Response to Technical Note 5 (Update)

**Brook Green
Land at Fritch Way, Rayne
January 2017**

**Response to Technical Note 05 (Update) – Brook Green
January 2017**

Type of report: Technical Note Response

client: Acorn Group Braintree	title: Springwood Drive Roundabout Improvements	date: 5/01/2017	scale @ A3 1:500
project: Brook Green	status: Planning	drawn:	Revision
discipline: Transport Planning	project no: JTP 06414	chk'd: SAA	dwg no: DR12

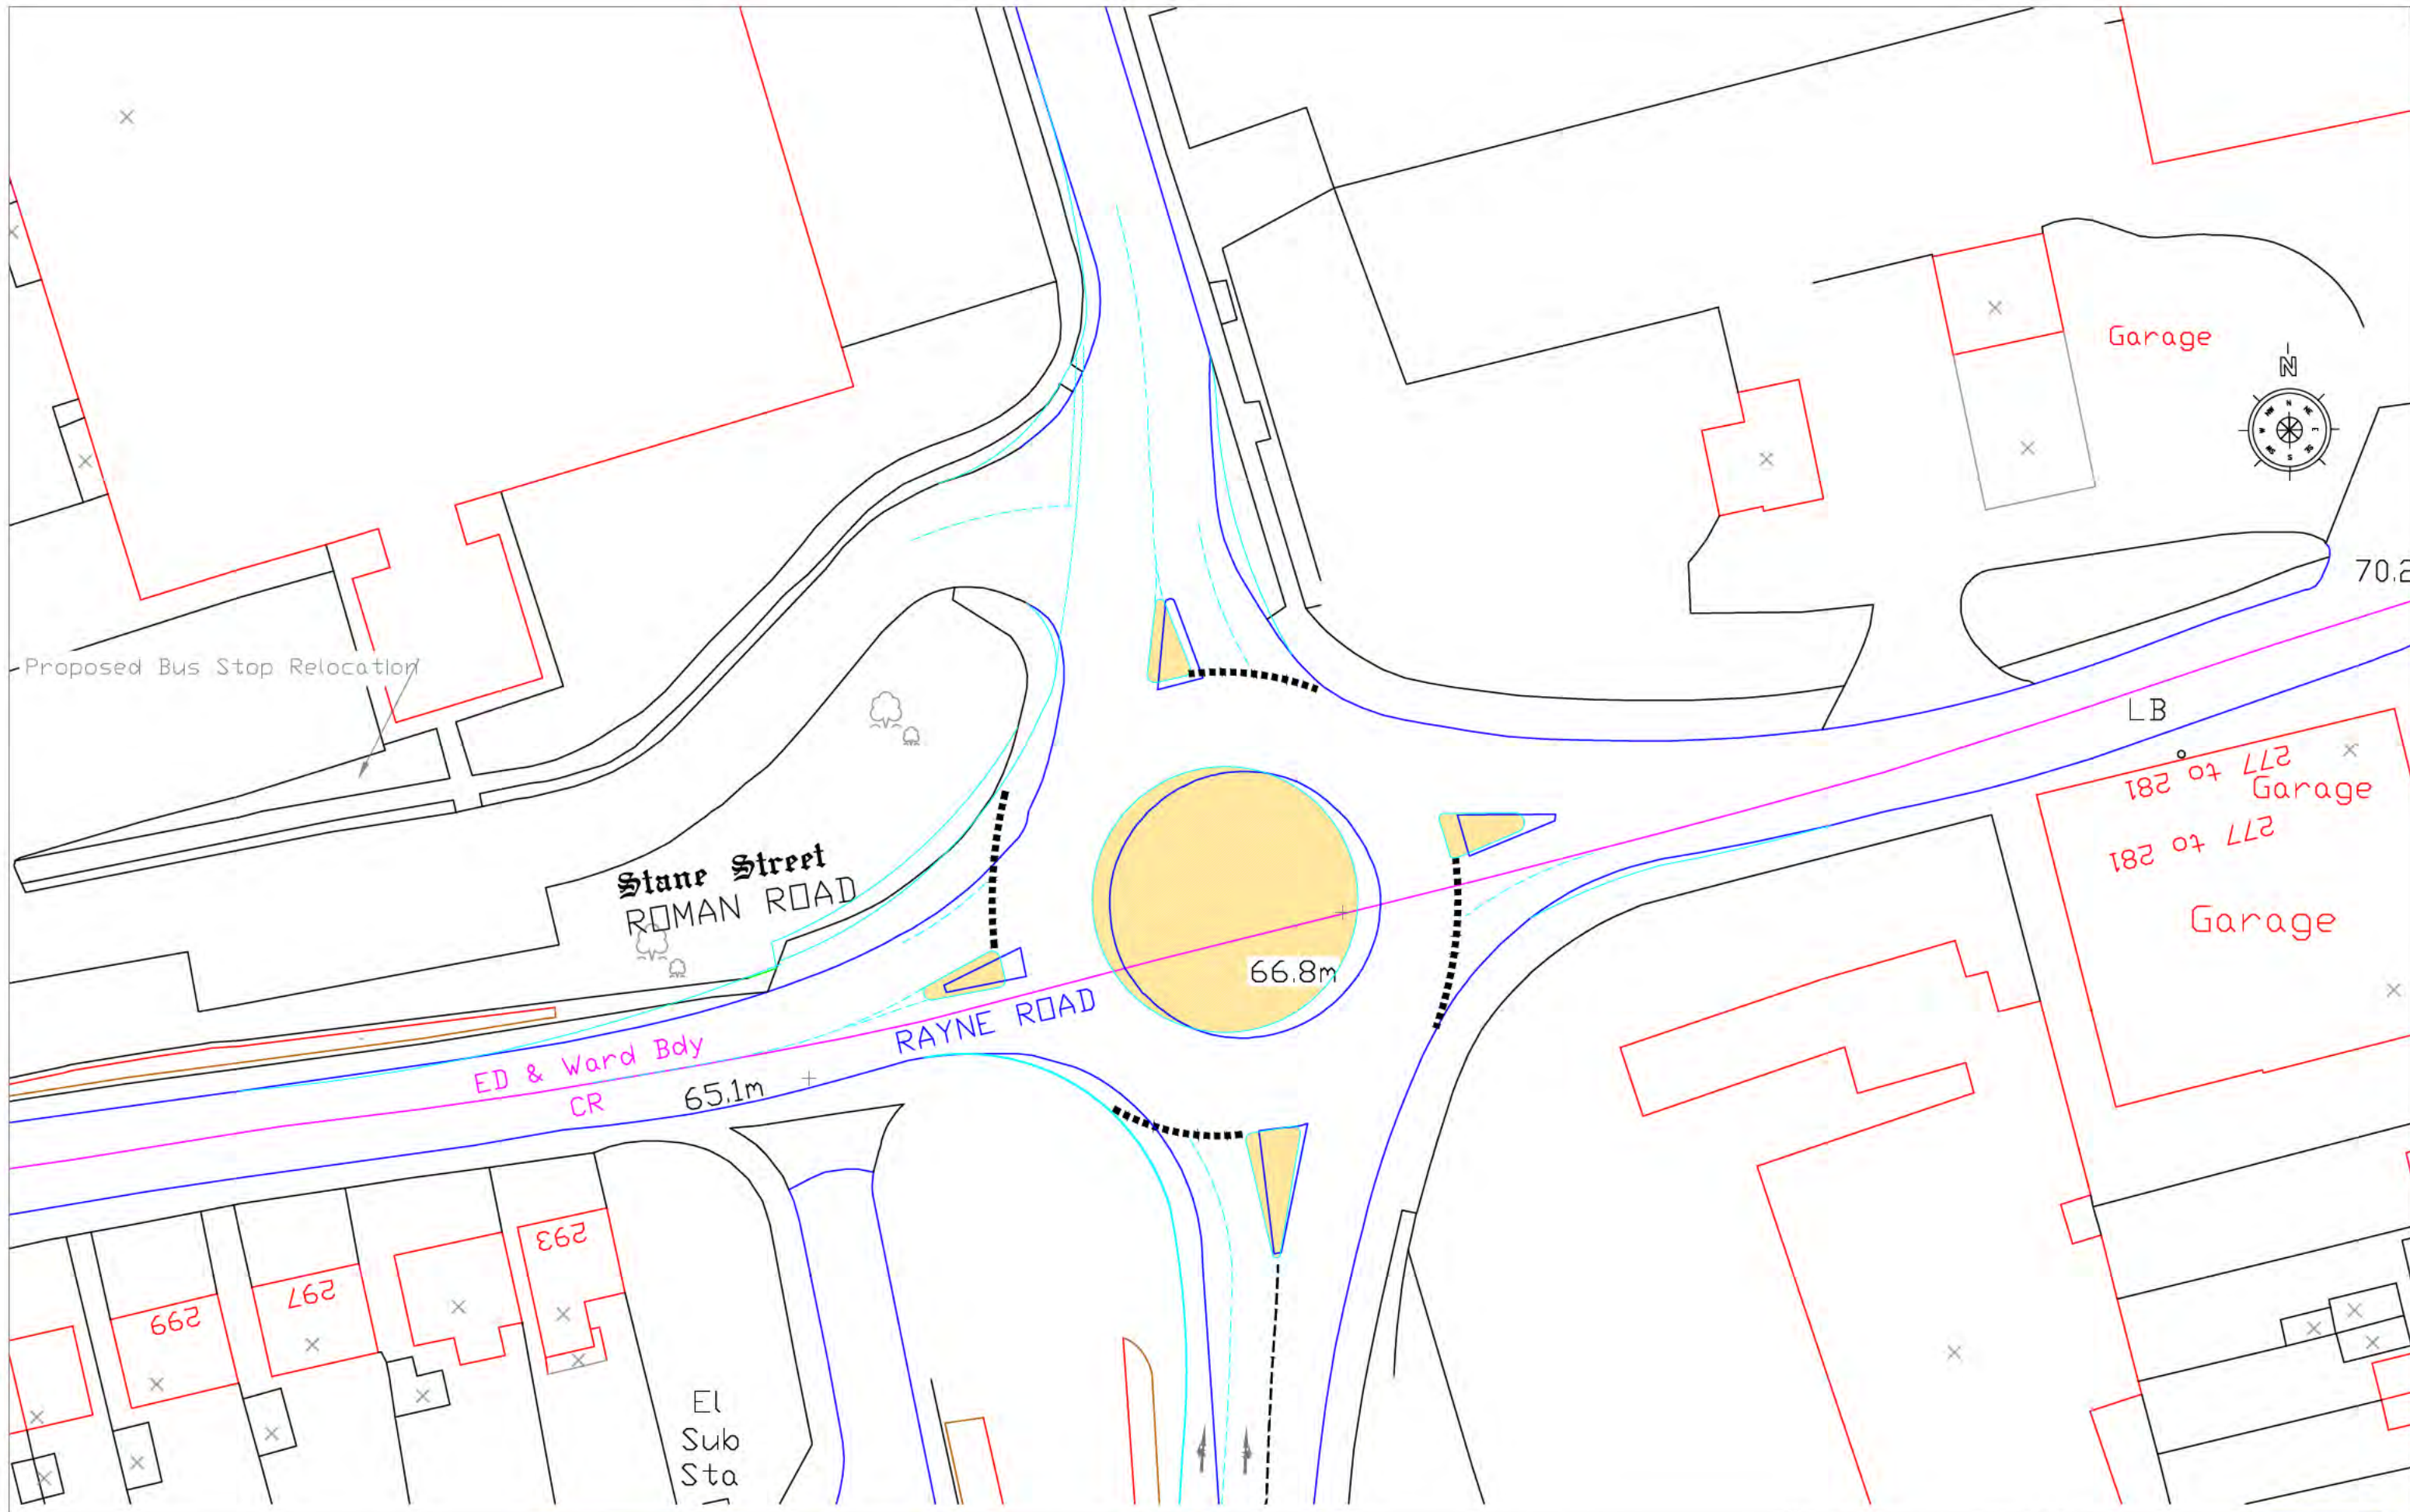
Springwood Drive Roundabout

- The modifications associated with the Panfield Lane development proposals have been incorporated into the design with some additional widening to the Springwood Drive approach.

3.7 The proposed Springwood Drive roundabout modifications are held in **Appendix 4**.
